CONSUMERS
POWER
COMPANY

MIDLAND PROJECT
DOCKET NO 50-329, 50-330
CONTAINMENT SUMP MODEL TESTING
FILE: M-382/942.9 UFI: 10801 SERIAL: 9069

Comments in Response to the NRC's
"Summary of Trip to Observe Midland Sump Tests"

Figure 1

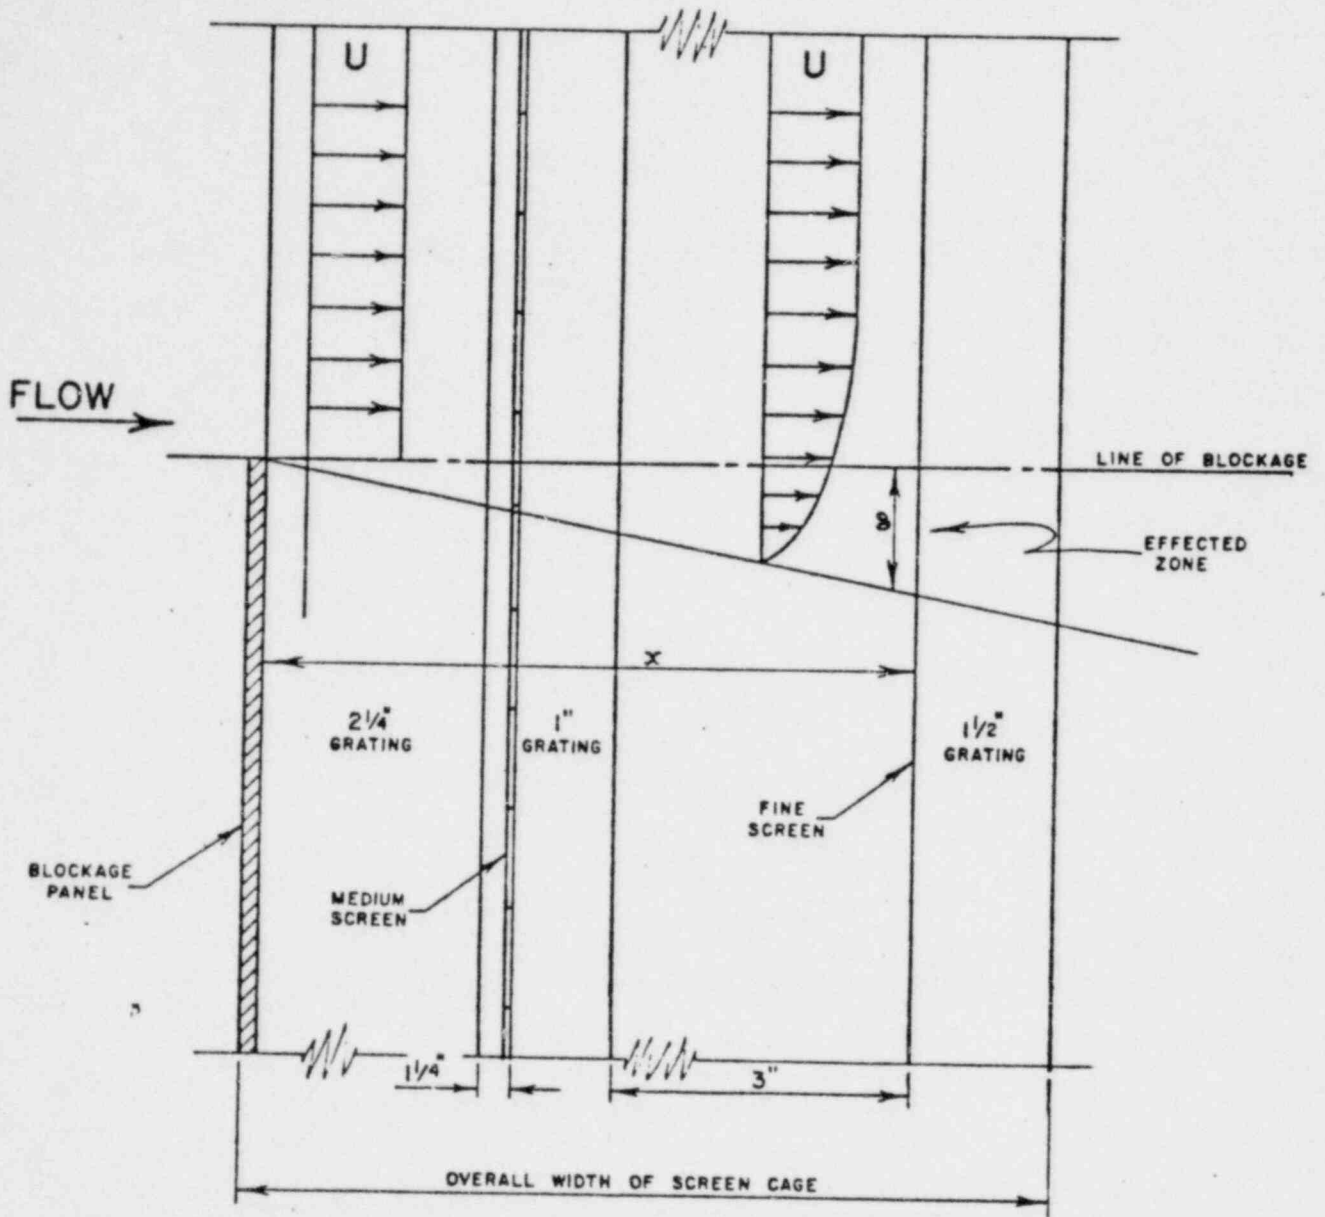
The NRC had expressed concern that screen blockage could not be simulated by blockage of the outer surface of the trash racks. The outer screen cage was described as consisting of vertical modules with no flow possible horizontally from one module to the next. Therefore, to the extent that such module is totally blocked on the outer surface, an equivalent area of screen would be blocked. Screen blockage by a combination of floating and sinking debris can not be simulated, however, unless the screens are blocked directly.

The construction of the Midland screen grating is shown in Figure 1. The fine screen blockage was simulated by placing sheet metal, 1/8 inch thick, in front of the 2-1/4 inch grating. As suggested in the above statement in Page 3, Paragraph 5, if an entire module of trash rack is blocked, then there is no question about the simulation of fine screen blockage. If only a portion of a module is blocked, then the 2-1/4 inch grating sees a velocity profile shown schematically in Figure 1. The velocity profile broadens in the region between the blockage₁ plate and the fine screen due to the action of viscosity.¹ The extent of the affected zone δ can be estimated from boundary layer theory as:

$$\frac{\delta}{x} = 5.0(Ux/\nu)^{1/2}$$

where U and x are defined in Figure 1 and ν is the kinematic viscosity of water. Assuming 50% blockage, the affected zone is approximately 0.17 inch in extent. Compared with the overall vertical open area dimension of 42 inches, the error in simulating fine screen blockage by panels outside the 2-1/4 inch grating is insignificant.
